DIXON RANCH RESIDENTIAL PROJECT RESPONSE TO COMMENTS DOCUMENT

STATE CLEARINGHOUSE NO. 2012062023

November 2015

County of El Dorado
Community Development Agency
Planning Services Division
2850 Fairlane Court
Placerville, California 95667

Excerpt from Figure III-5 (pdf pg,55/394)

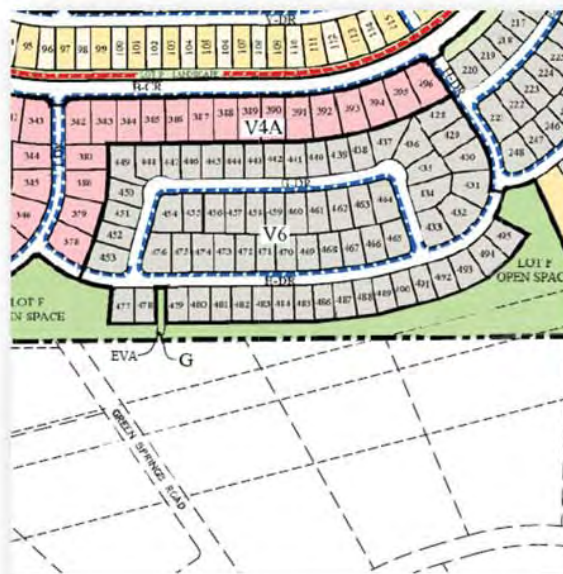
Contrary to this statement, the highest density lots are actually placed adjacent to the 5 acre parcels in Green Springs Ranch. This inconsistency with the DEIR statement and policy 2.5.1.1 is easily seen on DEIR Figure III-5:

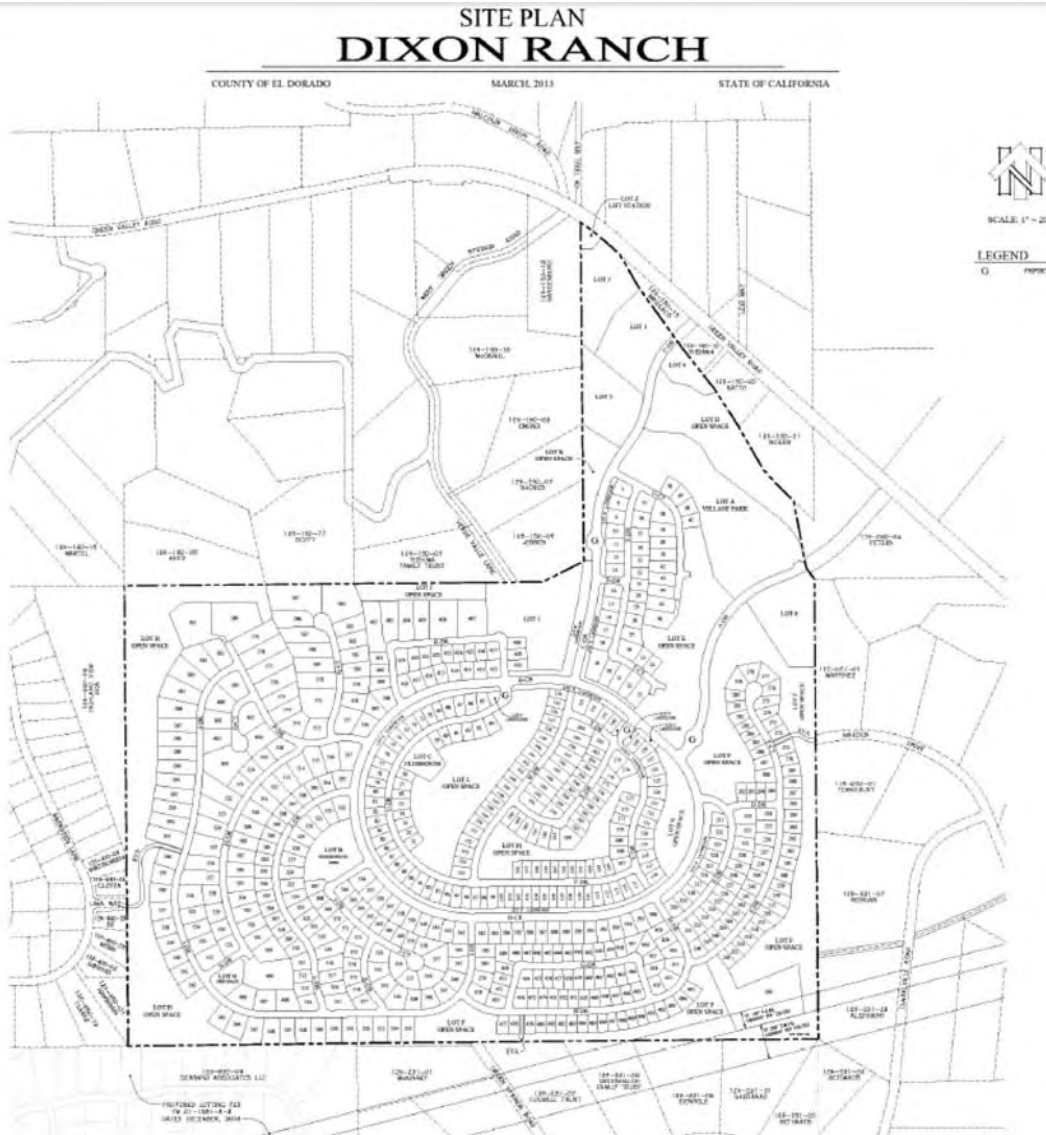
A look at a 'bare-bones' simple parcel map (below) shows the project's density increasing rather than transitioning down to the lower density of the Rural Region. Due to site access, the traffic impact is on the Green Valley corridor, and due to topography the visual impact is on the Green Valley corridor - so any new development on this site should be in keeping with the Green Valley corridor and surrounding rural character. But instead, the project design represents the maximum density possible for the Community Region, of which this site has no part except in name only. Even all of the services to the site require annexation into the appropriate districts (EID, fire, CSD, etc).

-How do lot sizes that grow increasingly smaller toward the Rural Region east of the project represent a transition to the large lots of the Rural Region?

-How is the project consistent with General Plan policies 2.2.1.2, 2.5.1.1 regarding density transition?

REVISÉD FIGURE III-3b

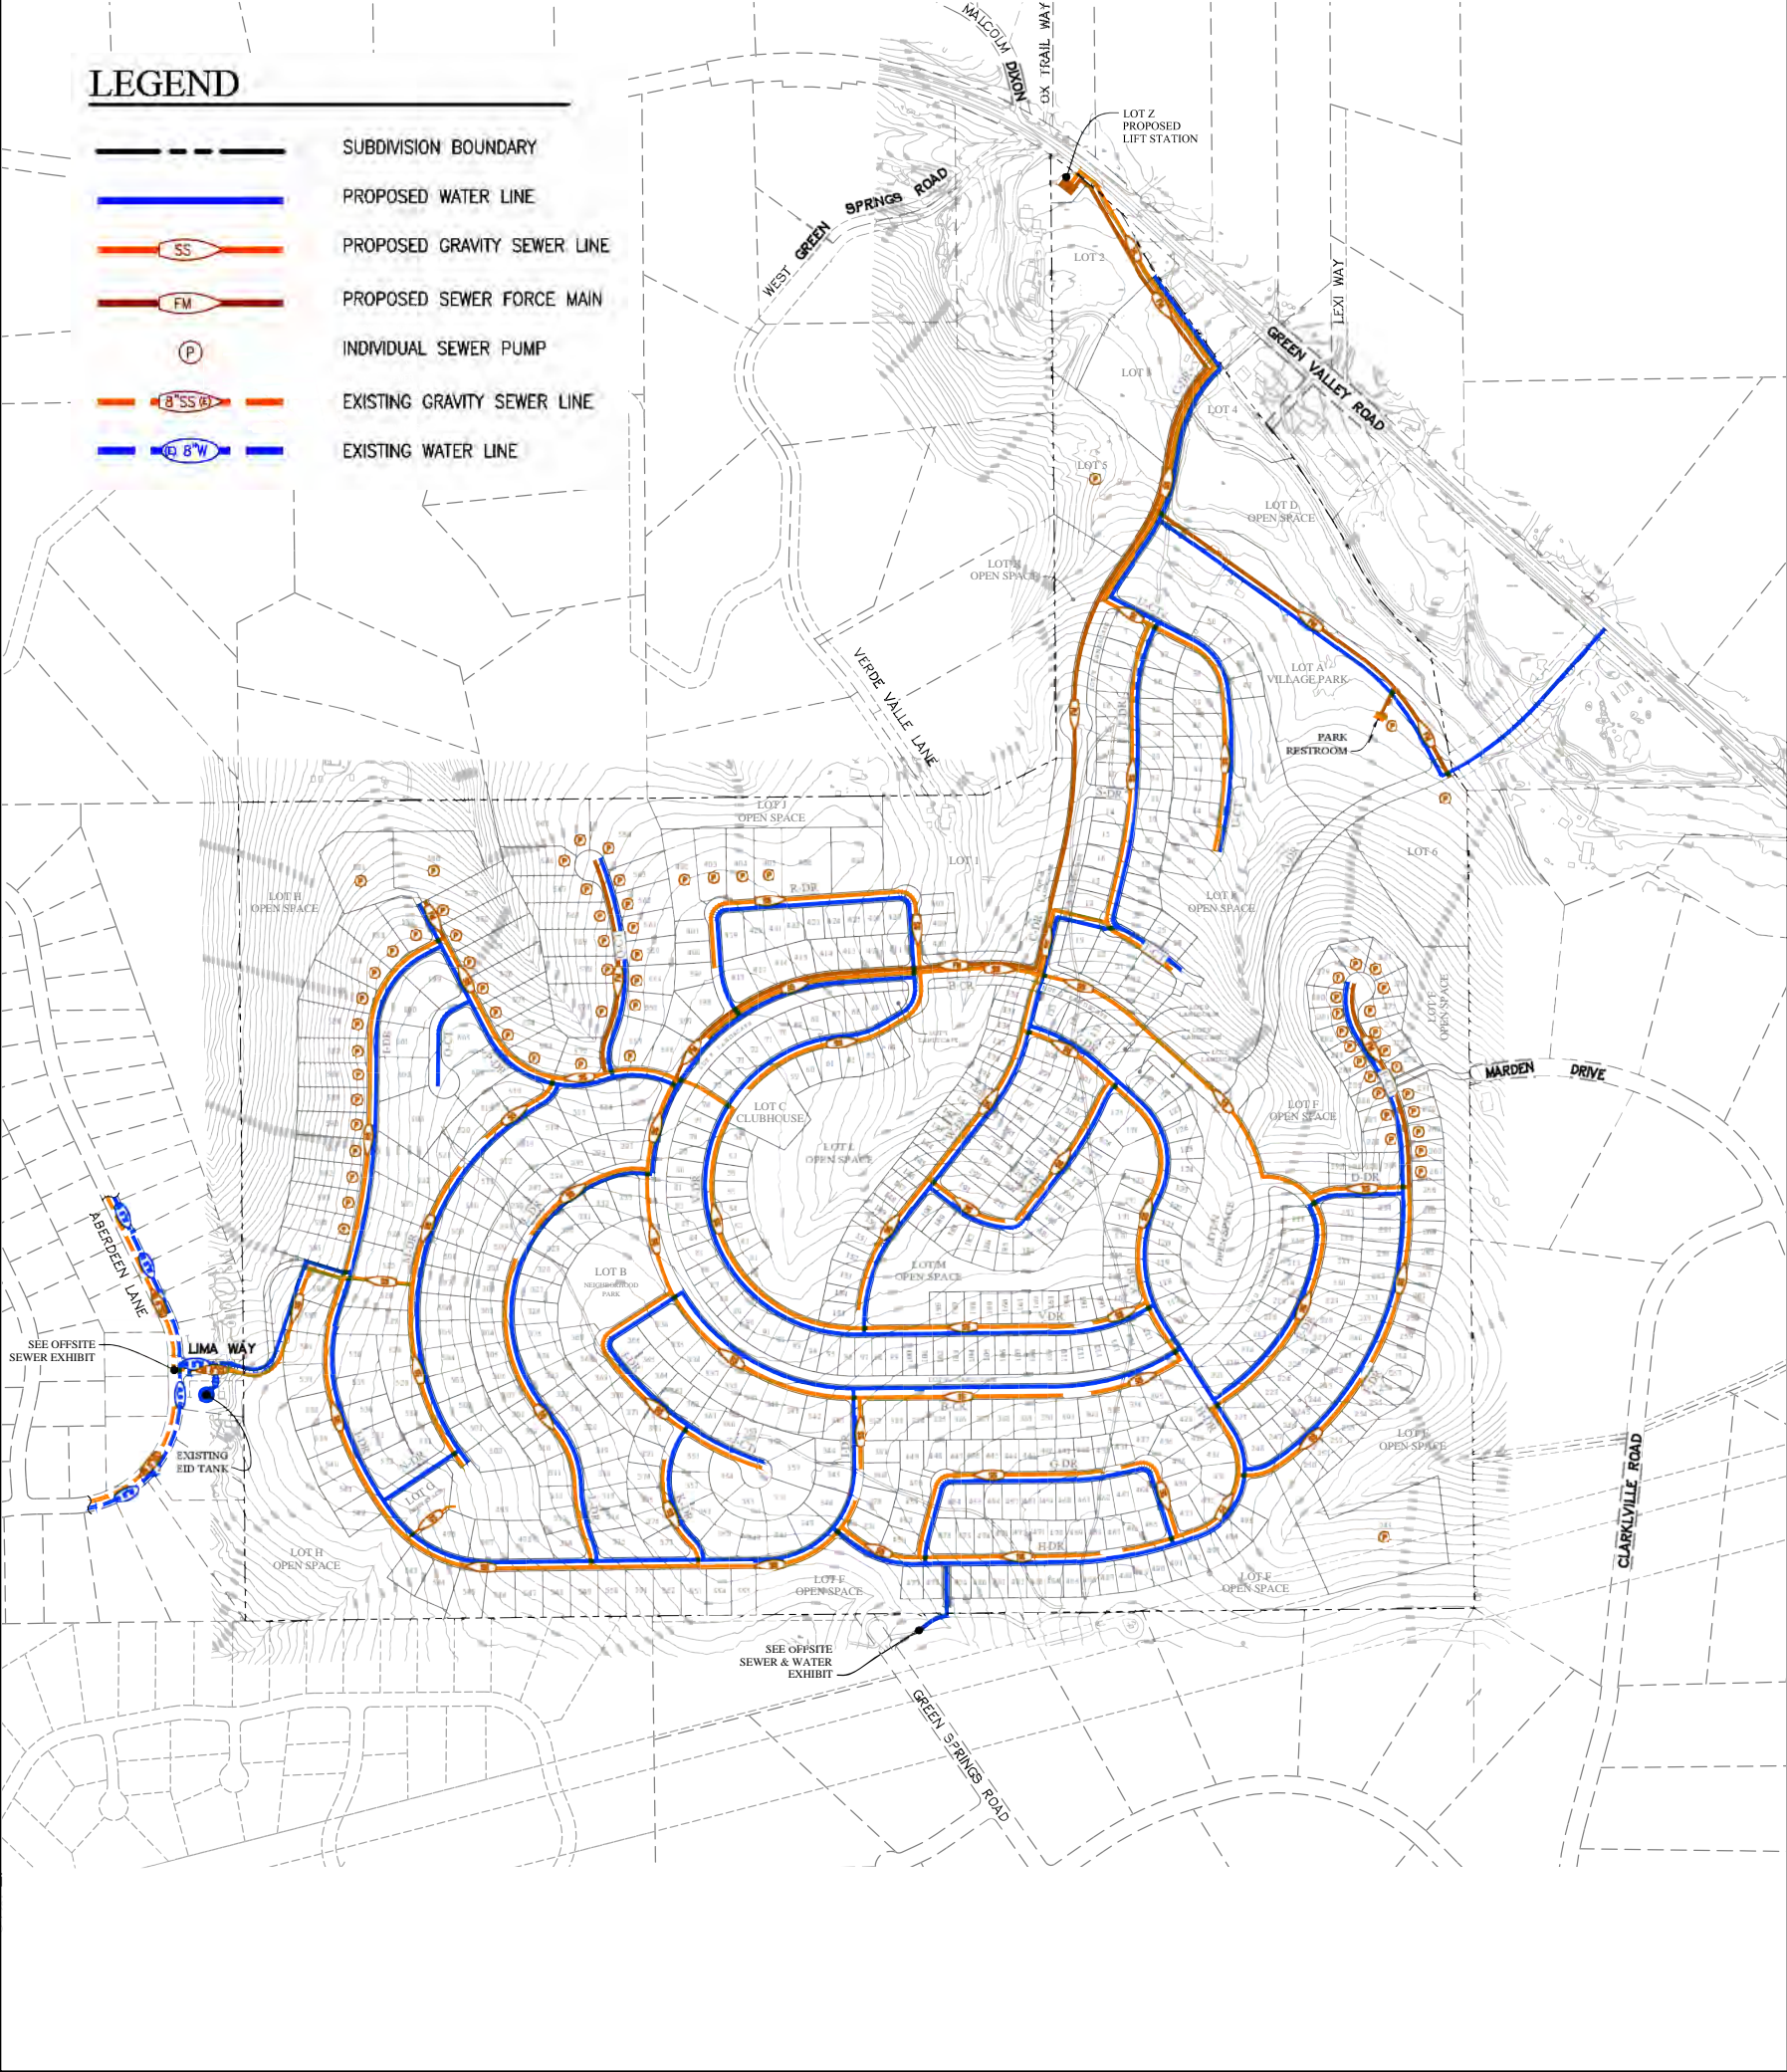
Response B25-60: Please see Master Response 4, which provides revised language for Mitigation Measure BIO-2a. The Draft EIR evaluated the environmental effects of both phases of the entire project (Draft EIR page 70), in accordance with CEQA. Phase 1 includes that portion of the overall tentative map and development plan that can meet the requirements for oak canopy retention and replacement under Policy 7.4.4.4 Option A. Phase 2 is the remaining portion of the project. Figure III-14 shows the locations of the phases. The estimate for canopy removal (44 percent) is for the entire project (Phases 1 and 2). This is shown in Figure III-3a. Figure III-3b has been revised to further show project phasing.

Phases 1 and 2 of Dixon Ranch are shown in Figure III-14 of the Draft EIR on page 71. Additionally, Figure III-3b was enhanced to further clarify the Phase 1 area of the proposed project. CEQA analysis is being conducted under this EIR for the entire project, including Phases 1 and 2 of the tentative map, the development plan, and the General Plan and Zoning amendments. Phase 1 of the development plan would be subject to the provisions under Section 130.04.010 of the Zoning Ordinance, including open space ratios. Phase 2 of the development plan would be reviewed under Subsection 17.04.010.A.7 as a sequential phase of the overall development plan. However, as with the Phase 2 tentative map, the Phase 2 development plan could only be conceptually approved by the Board at that time.

Figure III-3b on page 42 of the Draft EIR has been revised as shown on the following pages.
